GEORGETOWN-SCOTT COUNTY PLANNING COMMISSION

**AGENDA
JULY 8, 2021
6:00 p.m.**

Staff Report to the Georgetown-Scott County Planning Commission

**VILLAGE AT LANES RUN, PHASE 3, SECTION 2
AMENDED MASTER PLAN AND PRELIMINARY SUBDIVISION PLAT**

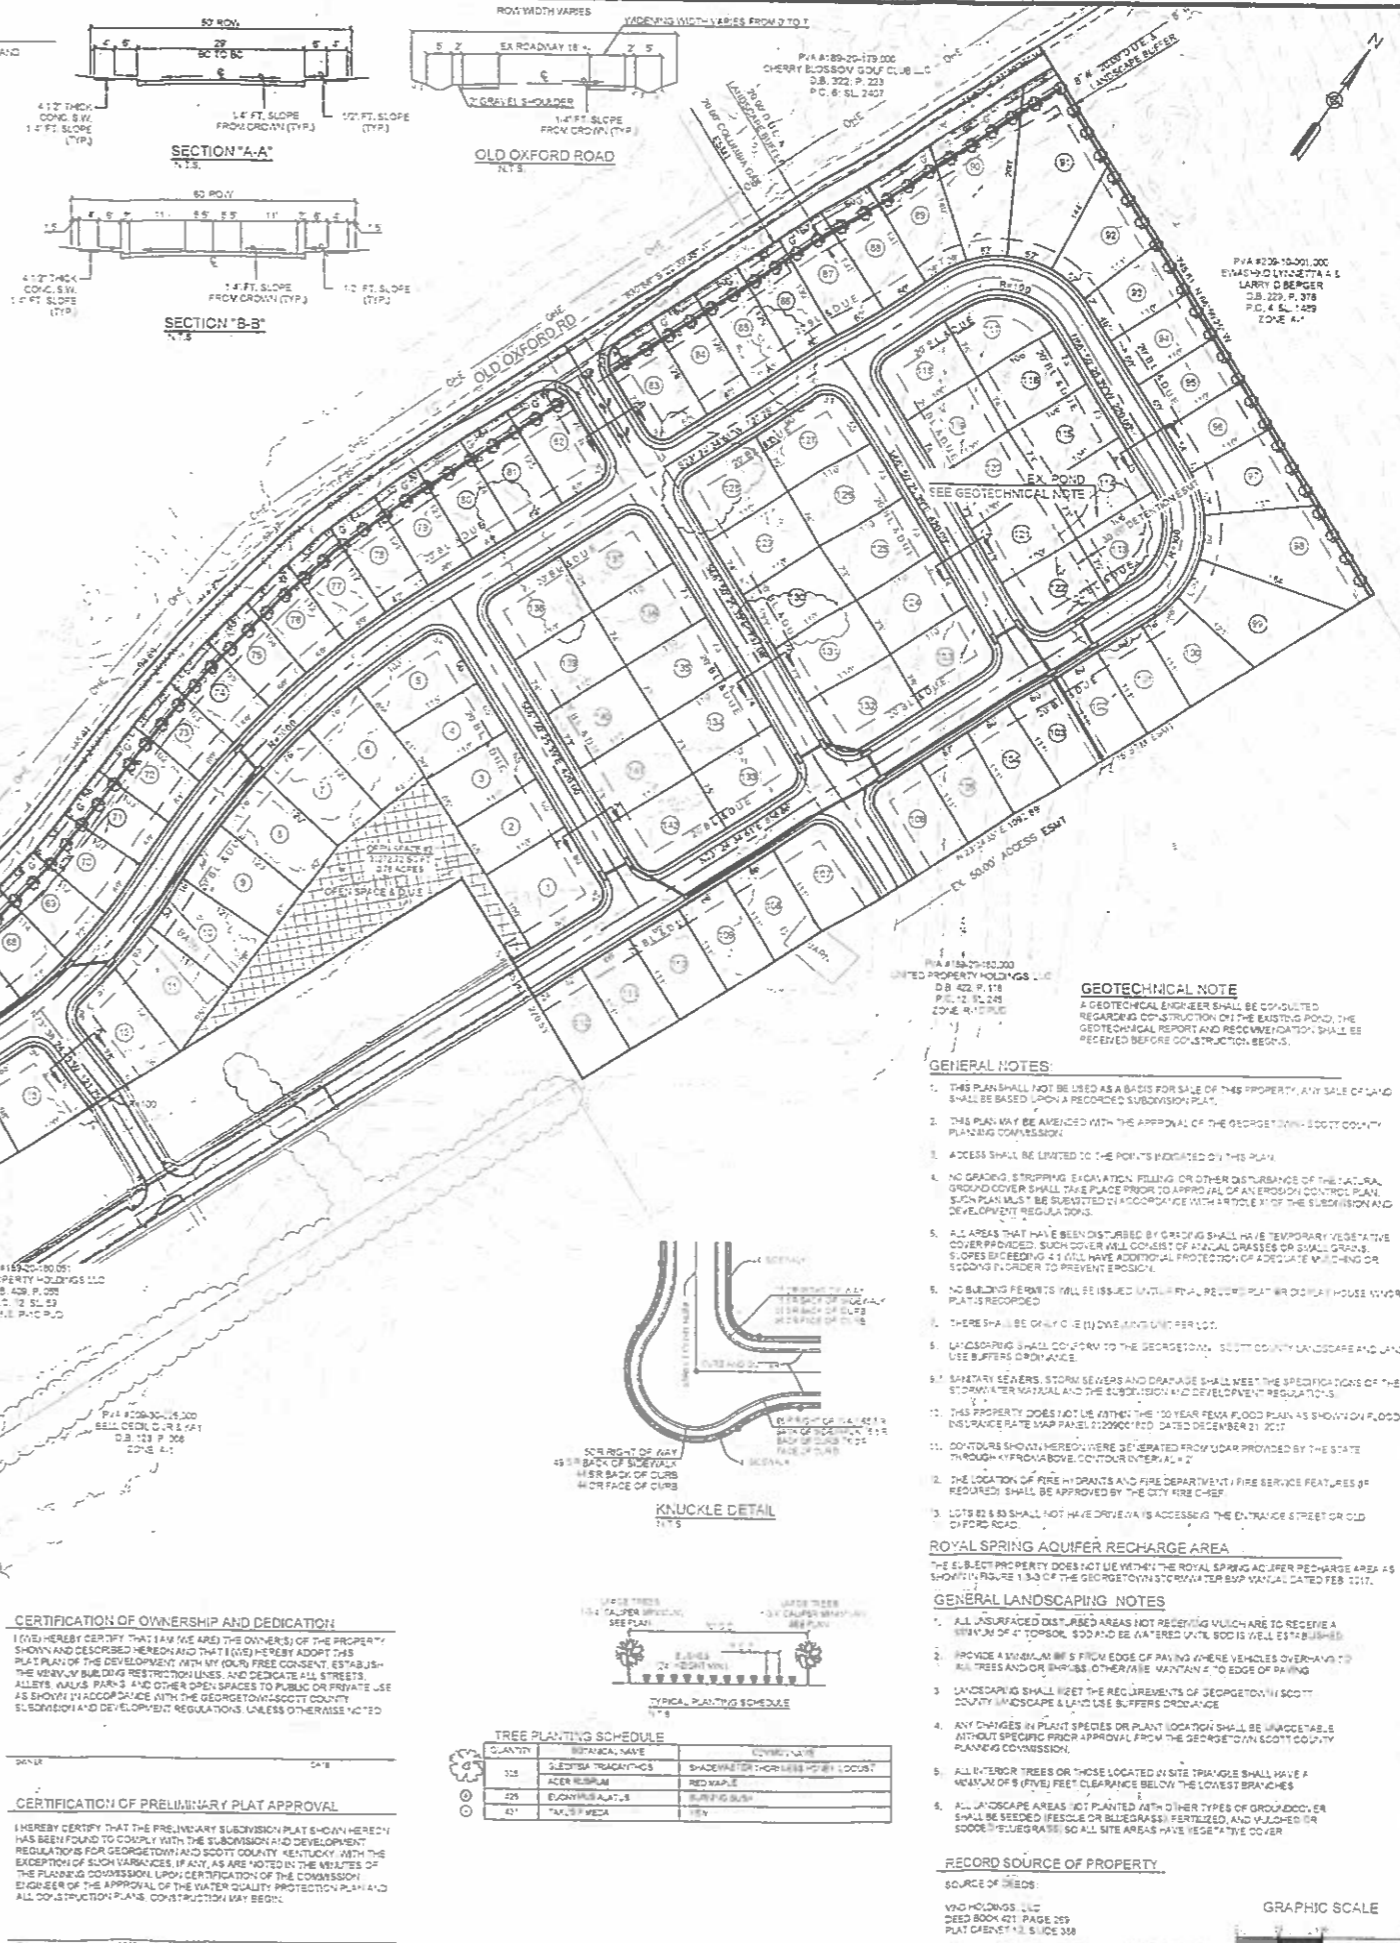
As part of this Amended Preliminary Subdivision Plat, the Applicant intends to remove all proposed private alleys (shown and approved in PSP-2004-26) on all lots within Phase 3, Section 2. There was no previous condition that the applicant must follow the TND pattern of development. Although Staff would prefer to have seen all alleys remain as part of the TND which is integral to creating walkable, pedestrian friendly neighborhoods, because of the previous decision to remove the proposed alleys in Phase 2, Section 1 (PSP-2010-22), Phase 2, Section 2 (PSP-2013-20), and Phase 1, Section 2 (FSP-2013-28), the same proposal in this case makes sense contextually.

The amendment to the open space in Phase 3, Section 2, which proposes to remove the linear park, which allowed for usable internal park space and the proposal to move park areas to the rear of lots, on leftover land poorly accessible is a pattern we have seen in the past, that is self-serving to the developer and provides little or no benefit to future residents. Staff cannot support this proposed change to the open space.

The applicant is showing the required buffer along Old Oxford Road for the double frontage lots. There are numerous easements and utilities in the ground along Old Oxford Road, so the depth of some of the lots along Old Oxford may make it difficult to get these buffer plantings installed in an effective way. The applicant will be required to provide this buffer and staff will not support a variance based on lot depth. An additional planted buffer is shown along Old Oxford subdivision to the north.

The applicant is proposing a new second entrance to Old Oxford Road east of Lanes Run Creek. The applicant will be responsible for completing all improvements at the new entrance including turn lanes and widening of Old Oxford Road to 11' from centerline along the frontage of the lots.

Staff recommends **Denial** of the Amended Preliminary Subdivision Plat for Phase 3, Section 2. The proposed amendments particularly the change in the open space arrangement and the reduction in the minimum lot widths throughout the phase and the increase in the number of lots due to the above proposed changes are not supportable in terms of the original PUD approval.

1. All applicable requirements from the previous approval (PSP-2004-26).
2. Provide a minimum of 2-acres of open space/park area distributed throughout phase 3, section 2, with a minimum of 100-feet of road frontage each.

WHITAKER PROJECT PRELIMINARY DEVELOPMENT PLAN

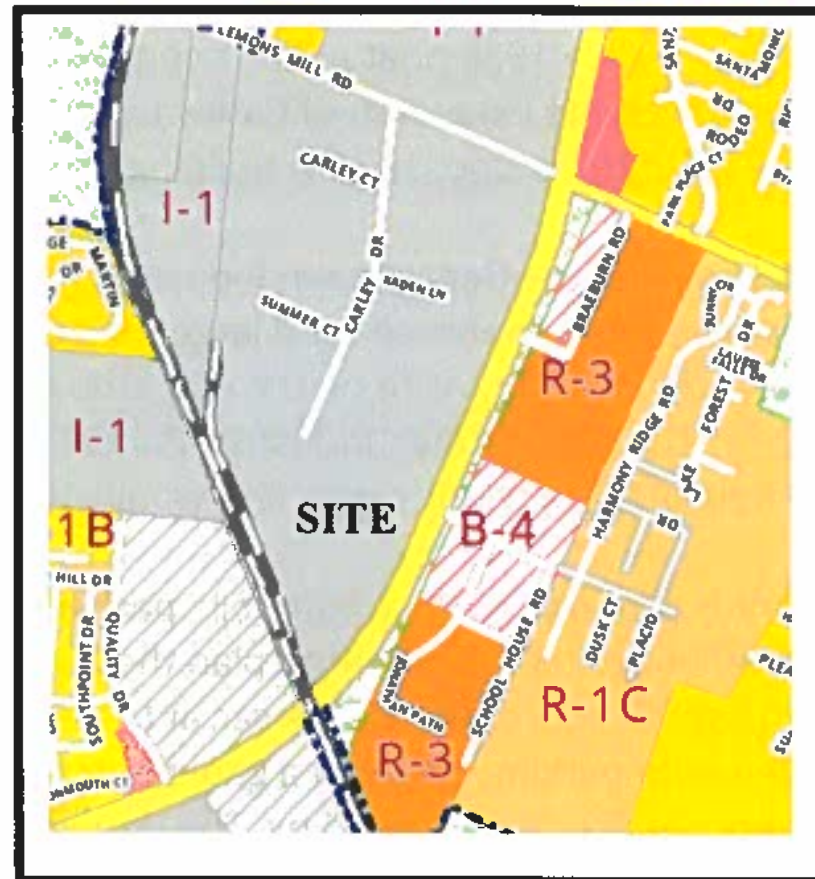
The Applicant is proposing 605 automobile parking spaces north of the proposed warehouse distribution building. In the submitted plan the auto parking lot is accessed by a private drive which enters off the south side of the cul-de-sac at the end of Kaden Lane. This drive will also continue around the employee auto parking, through a gated entrance to the van staging and parking lot on the east side of the warehouse/distribution building. The parking and drive will continue around the buildings south side and connect to trailer and semi-truck parking and dolly staging areas on the west side of the building. Kaden Lane currently serves as access to United Talent and Vuteq's main parking areas and has seen increased congestion/conflicts after Vuteq's most recent expansion.

There are 183 semi-trailer spaces proposed on the west and south sides of the building, accessed by a drive around the building, but primarily accessed by an extension of Carley Drive which will provide direct access to the west side of the warehouse/distribution building. A cul-de-sac at the end of Carley Drive will need to be constructed within public right-of-way, to provide a public street turn-around prior to the gated entrance to the facility.

The Traffic Study shows that there is a LOS deficiency on Lemons Mill Road and there are real potential impacts to existing businesses and operations and their ability to expand within Georgetown Industrial Park and on Lemons Mill. An entrance was proposed and planned on the bypass to serve the Georgetown Industrial Park. This will not be the only facility in the park. Industrial Parks need to be flexible in their planning to allow for the changing requirements of different users. It is staffs recommendation that a direct access to the McClelland Circle bypass is needed to handle the additional traffic generated by this development and to allow for potential future expansion needs of existing established business.

Staff recommends that this application be approved with the condition that the applicant amend the parking and driveway configuration to allow for an additional access directly to the McClelland Circle bypass. This connection could serve the auto and van lots only and could be approved as an Amended Final Development Plan at a later date so as not to impact any planned construction schedule.

1. Applicant shall provide a direct driveway connection to McClelland Circle to serve the facility. A Final Development should be submitted for approval showing the connection.
2. All applicable requirements of the *Zoning Ordinance* and *Subdivision & Development Regulations*.
3. Any revisions or amendments to the approved Preliminary Development Plan shall be reviewed and approved by the Planning Commission staff (minor) or by the Planning Commission (major).
